PRODUCT CHANGE NOTIFICATION

Select Bourns® Metal Oxide Varistors

Terminal Type Change

GDT2136

BEFORE

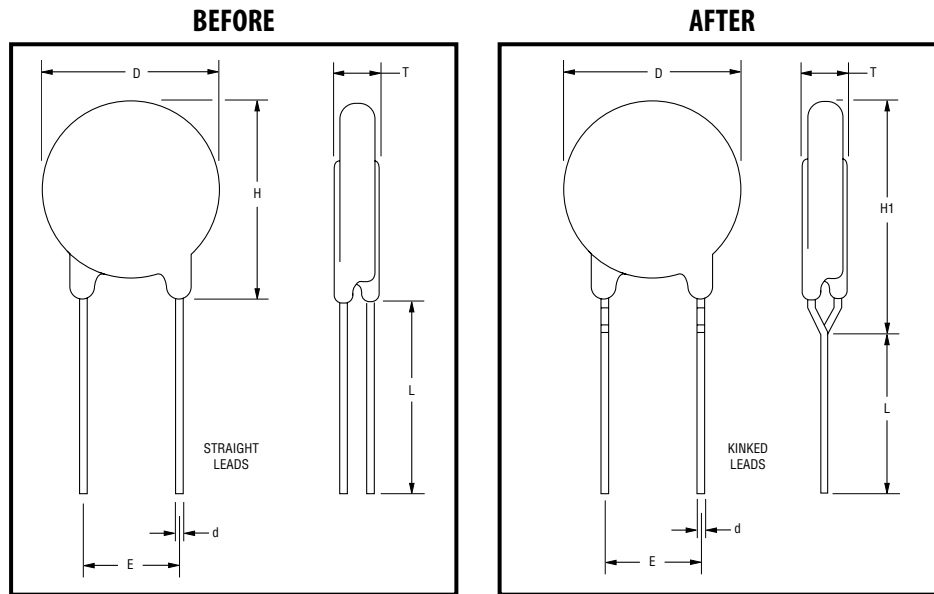
Riverside, California – September 14, 2021 – Effective October 15, 2021, Bourns will change the terminals of select Bourns® Metal Oxide Varistors from straight leads to kinked leads. To comply with UL requirements, the thickness of the MOV ceramic disc was increased in the parts listed below.

The form of the MOV will change due to the change in appearance of the new terminals. The fit of the varistors will change because of the change in the type of terminals. However, the lead space between the connecting leads will not change so the same mounting pads can be used as before. The function, quality and reliability of the varistors will remain the same. The images below show the changes.
